<b>EASA</b>	<b>COMMENT RESPONSE DOCUMENT</b>
	<p align="center"><b>EASA PAD No. 12-119</b></p> <p align="center"><b>[Published on 14 September 2012 and officially closed for comments on 12 October 2012]</b></p>

**FIGURE 1 – Threshold and Repeat Inspection Intervals Based on AFT Values  
(Freighter Configured Aircraft)**

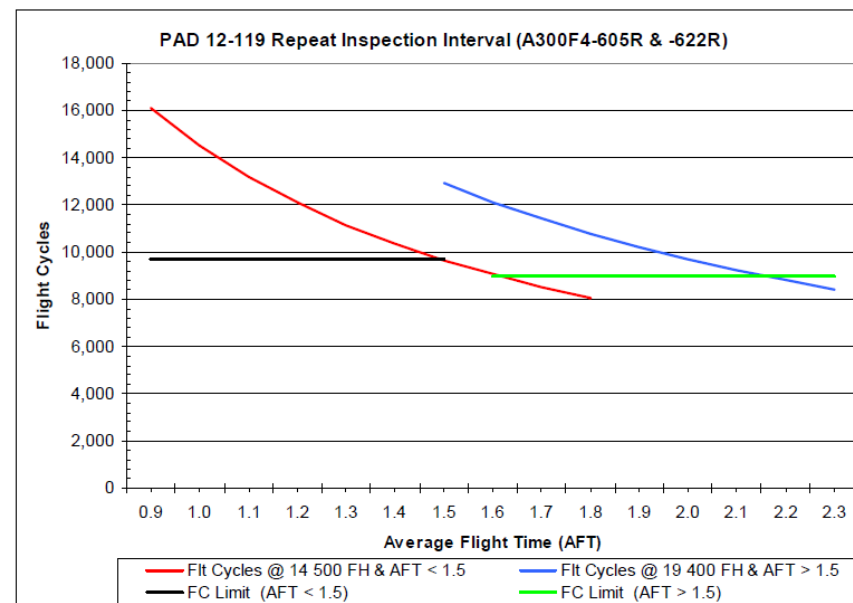
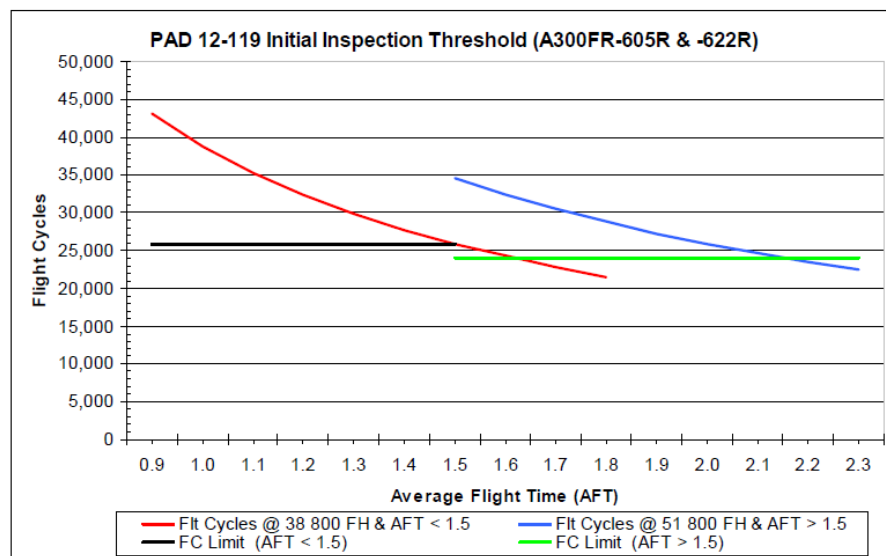
Under the current proposed threshold for aircraft utilization below the 1.5 AFT value (“short range” operations), the aircraft is flight cycle limited as the flight hour limit cannot be reached without being classified as a “normal” operations aircraft (reference Figures 1 and 2). In the “normal” operations category, the aircraft is still flight cycle limited until an AFT value of 2.16 is achieved. As the flight hour limitation for an AFT value below 1.5 cannot be achieved, the flight hour limit adds an unnecessary complexity to the threshold table. Additional investigation notes that the A300-600 Airworthiness Limitation Items (ALI) Issue 13, dated October 2010, Part 2, Section B, paragraph 7, established industry guidelines and provisions to address utilization differences between aircraft operations. Adjustments to the published values are typically for average flight times (AFT's) greater than 2.1. For AFT values below 1.5, the thresholds in the ALI document are valid and no adjustments are required. The philosophy and practice used in the proposed ruling appears to be inconsistent with the industry standard and policy established in the ALI program.

EASA disagrees with the second comment regarding the inspection threshold and repetitive intervals identified in Tables 1 and 2 of the AD Appendix.

It must be emphasised that the current method named "Range Effect" was first presented by Airbus to its WB operators in 2005 during a STG and that for approximately 8 years, UPS seems to be the sole operator to question the benefits of the new method. The original approach used at AIRBUS to cope with Range Effect (i.e. the way a longer flight duration negatively influences the fatigue and crack growth lives of aircraft structural elements) was to adjust the maintenance tasks, using a parameter called Fatigue Ratings. Standardized Fatigue Rating values were provided for each inspection task in Maintenance Programmes and Airlines/Maintainers had to adjust their maintenance tasks function of each A/C utilization. EASA has been told that this approach was progressively abandoned from 2000 onwards, because of the difficulties for the Airlines in implementing it and for the Airworthiness Authorities in controlling and monitoring its implementation. A proposed solution was the - currently used - concept for Range Effect. The merits of this method are that it accounts for mission mix, does not request adjustment of maintenance figures by the Airlines and provides Flight Cycles and Flight Hours pair "caps" for each maintenance tasks where Flight Hours are relevant.

This method is not only in use for the A300-600 series aeroplanes but on most of the Airbus types. Besides, for aeroplanes close to the transitional AFT (1.5 in our case) the method has such a conservatism that the use of either of the two pair-caps does not compromise the airworthiness of the aeroplane to be inspected.

However, EASA concurs with the commenter when he says that the Service Bulletin does not provide sufficient definition as to when the AFT value is determined or if the AFT value is to be continually monitored over the life of the aircraft. As a response to this shortfall, the Final AD will be modified to explain when and how the AFT is to be determined. Airbus will also amend its ALI documentation to prevent any future misinterpretation in the implementation of the method and calculation of the AFT for determining the inspection threshold and interval.
